Product: Ishida WM-Ai Automatic Wrapper

Issue: Insertion Plate Sensor Harness Tension

Contents: Re-routing and Securing the Insertion Plate Sensor Harnesses

(Figure 1)

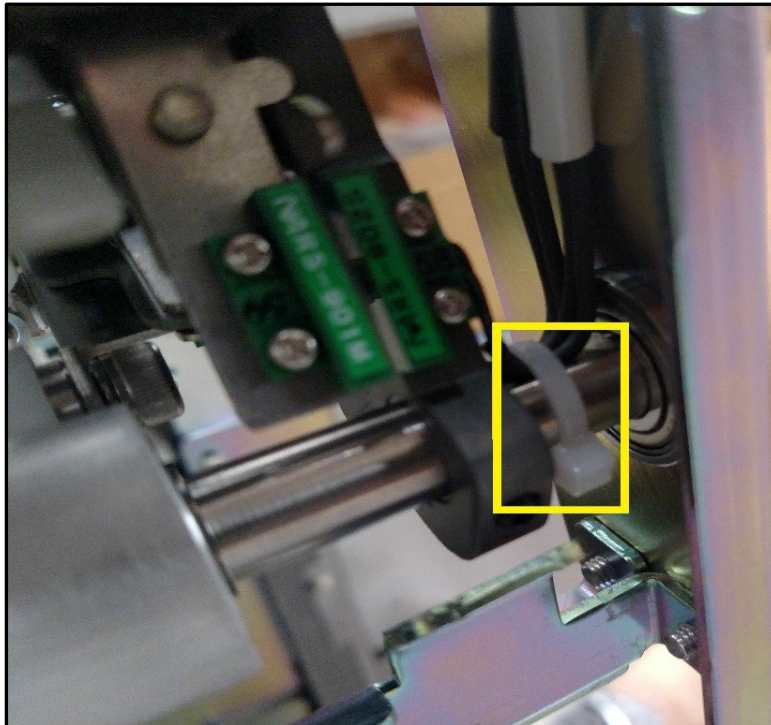
1. Power off the machine and unplug the power cable.
2. Open the left side film door shown in figure 1.

(Figure 4)

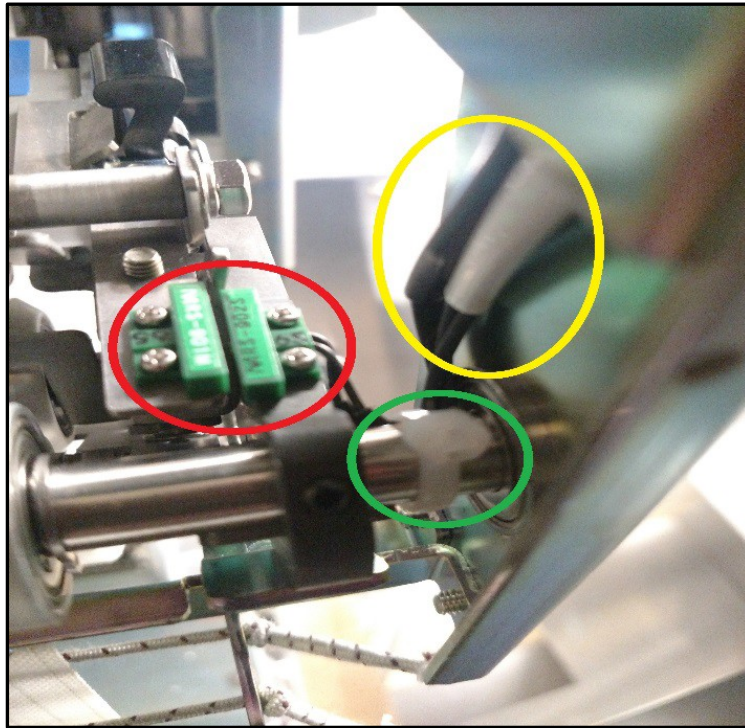
5. After removing the cutting bracket, gently pull both of the harness cables towards the front of the machine about half an inch. This will provide sufficient slack for the next step.
